Subject: Waterford 3 SES
Docket No. 50-382
Construction Appraisal Team Findings 6.2 and 6.3 -
Masonry Wall Deficiencies

BY A. LEON DATE 11/28/84SHEET 1 OF 2CHKD. BY G.W. DATE 11/29/84OFS NO. _____ DEPT. NO. 653CLIENT LP & LPROJECT WATERFORD SES IIISUBJECT CLARIFICATION OF STRESSES ORIGINATED FOR 6" PIPE THRU WALL S1

Condition 1.

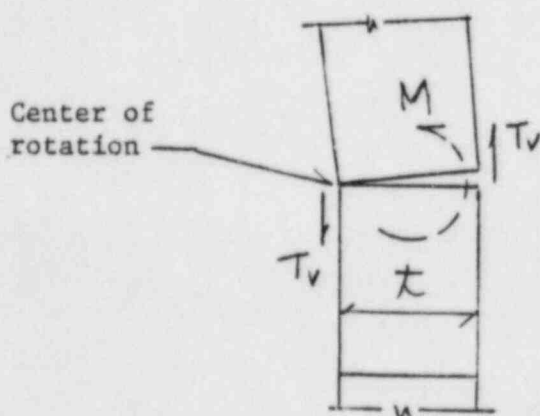
For the case in unequal moments on each side of penetration, 6" ϕ pipe at Wall S1 is analyzed.

The weakest location of the block wall is at the joint which bounds the blocks together horizontally and vertically.

The failure modes of joint are:

- (1) Tension forces associated with the induced moment tends to open the joint up in a vertical direction.
- (2) Shear force pushes the block off the wall.

Due to the nature of the block wall, the geometry at failure under condition 1 is as follows:

$$T_v = \frac{M}{t} \approx \frac{M}{6}$$

Where M: the induced moment
t: thickness of one wythe

This condition has been analyzed on Sh. 42.4 & Sh. 42.5.
